S E R V I C E N O T E

HP 8751A Network Analyzer

Modification to prevent the HP 8751A from hanging up when being controlled by a controller.

Figure 1. A1 and A2 Boards

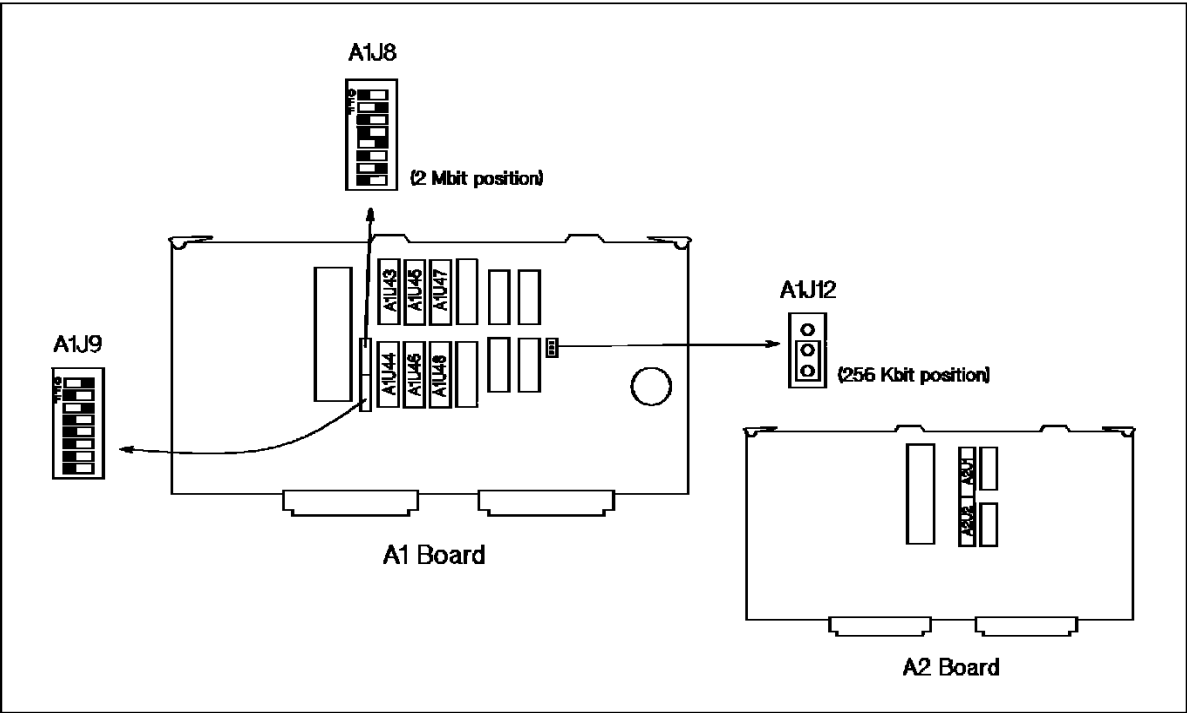
It is fixed from the firmware Rev.4.02. Replace ROMs on the A1 and A2 boards with Rev.4.02 ROMs.

- a. Remove only the A1 board.
 - b. Replace the ROMs of the A1 board with Rev.4.02 ROMs. Table 1 and Figure 1 show the ROM locations.
4. If the revision is "Rev.3.xx" and below,

- a. Remove the A1 and A2 boards.
 - b. Replace the ROMs of the A1 and A2 boards with Rev.4.02 ROMs. The ROM locations are shown in Table 1, Table 2 and Figure 1.

- c. The Figure 1 shows the jumper and bit switch settings for Rev.4.02. In case of any difference, replace RAMs and change the switch settings with referring the Modification Note (P/N 08751-90034).
